# Access Compliance Report

## Public Rights-of-Way

### (Island Curb Cuts)

Intersection ID: 48197	Main Street: BLAKENEY_PARK_DR	Cross Street: ARDREY_KELL_RD	Location: S
ADA ID: 6D27FAF3D870	Curb Cut Type: MedianRefuge2	Initial Pass/Fail: Fail	Overall Compliance: No
Severity Score: 13.75			
Codes/Mitigation Info/Possible Solution		Field Measurements/Component Compliance

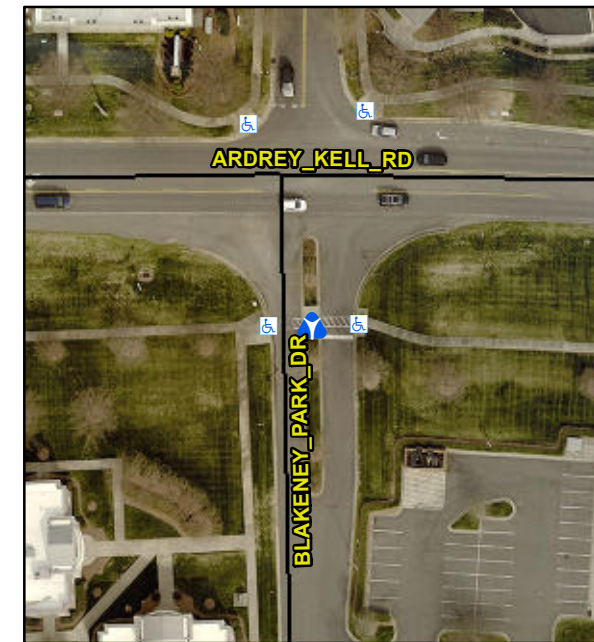
**Remove & Replace Entire Refuge.**
